Product Change Notification / LIAL-08IMMO486

CCB 4508 Initial Notice: Qualification of NSEB as a new assembly site for selected ATTINY20, ATTINY40, AT42QT2120, AT42QT1070, AT42QT1050 device families available in 20L VQFN (3x3x0.85mm) package.

CCB 4508
Pre and Post Change Summary
Lead Frame Comparison
PCN#: LIAL-08IMMO486

Pre change

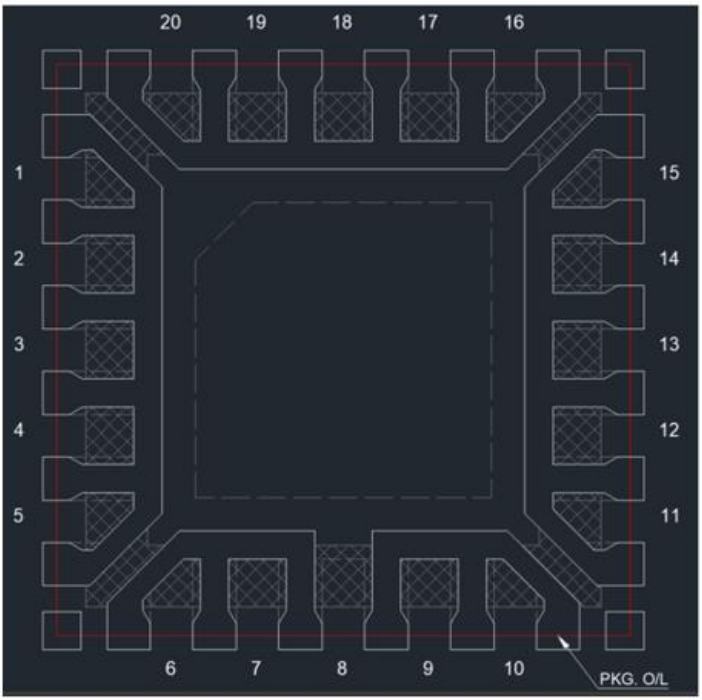
Assembled at ASKR using gold (Au) bond wire or palladium coated copper wire (PdCu) bond wire, EN-4900GC die attach material, C7025 lead frame material, NiPdAu lead frame lead plating, Spot plating lead frame DAP surface prep and without lead lock lead frame.

Lead frame lead-lock	No
----------------------	----

Post Change

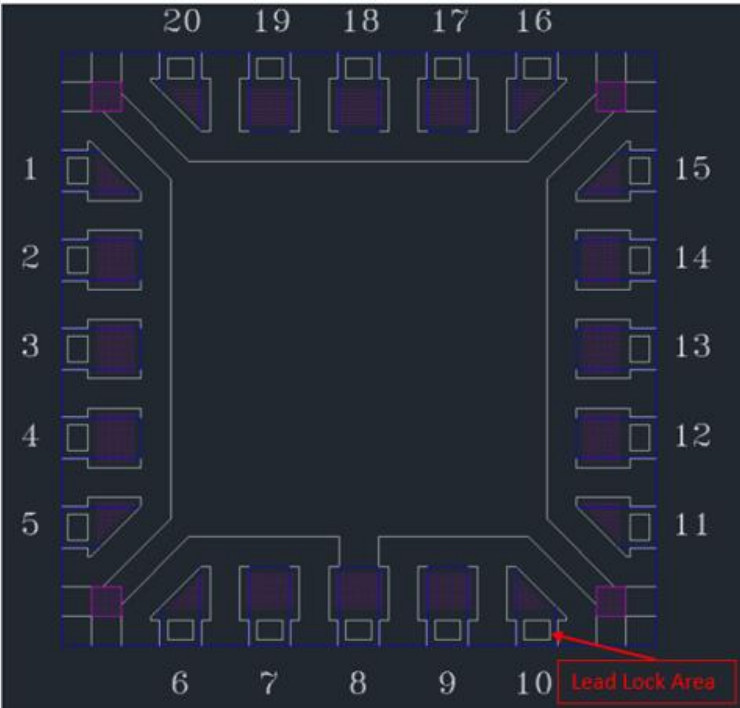
Assembled at NSEB using palladium coated copper with gold flash (CuPdAu) bond wire, 8600 die attach material, C194 lead

frame material, Matte Sn lead frame lead plating, Ag on lead only lead frame DAP surface prep and with lead lock lead frame.

Lead frame lead-lock	Yes
----------------------	-----
